Office Action Summary	Application No. 10/518,633	Applicant(s) ARMER ET AL.	
	Examiner DNYANESH KASTURE	Art Unit 3746

DETAILED ACTION

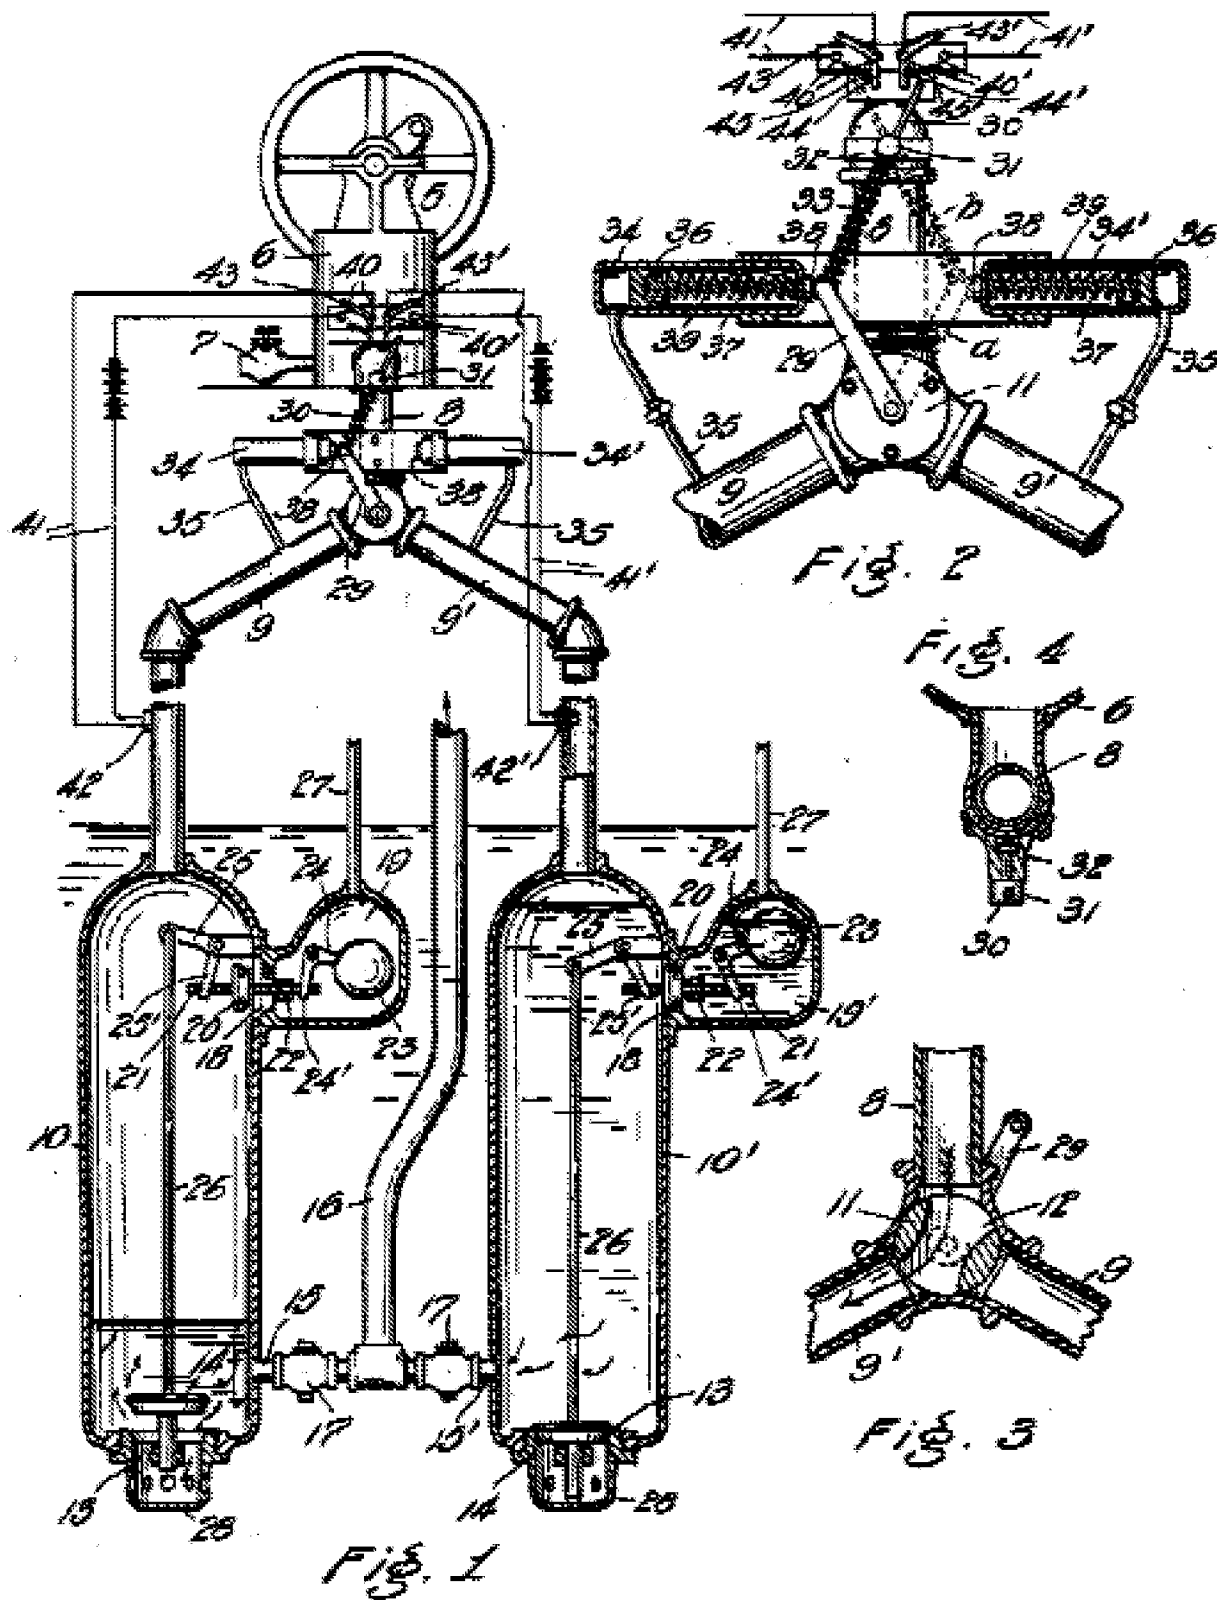
5. In Re claim 1, with reference to Figures 1-4 as depicted above, Emmons discloses a pumping apparatus described as:

- a first container (10) including a pressurisable chamber
- an inlet (13)
- an outlet (15)
- a control apparatus (21,22,23,24,25)
- second container (19)
- pilot valve (20)

- second container (19) receiving liquid from the first container (10) through passage (18) when the liquid in the first container (10) reaches the level of passage (18)

- the pilot valve (20) configured to close the passage (18) and when the float (23) rises in response to the liquid in the second container (19). The closing of the valve (20) triggers a pressurization cycle for the motive fluid that enters through pipe (9). The motive fluid exits through pipe (27) during the depressurization cycle.

- with regards to "state" of pilot valve determining pressure within a portion of the apparatus, when the pilot valve (20) opens passage (18), the pressure is not allowed to build up in the main chamber and when the pilot valve (20) closes passage (18), the pressure is allowed to build up in the main chamber

- with regards to "shuttle valve configured to change state in response to pressure within a portion of the apparatus", valve (11) switches position (changes state) from one

main chamber to the other directly in response to pressure buildup of compressed gas in the filled chamber (portion of the apparatus)

- with regards to "state of the shuttle valve determining whether the motive gas enters into or is vented from the first container thereby implementing the pressurization/depressurization cycle", when the conduit (8) is communicating compressed gas to conduit (9'), conduit (9) is blocked off, this "state" occurs in response to build up of pressure within a portion of the apparatus - chamber (10). Conversely, when the conduit (8) is communicating compressed gas to conduit (9), conduit (9') is blocked off, this "state" occurs in response to build up of pressure within a portion of the apparatus - chamber (10'). These state changes (in response to pressure within the main chambers) along with subsequent combustion implements the pressurization/depressurization cycle.
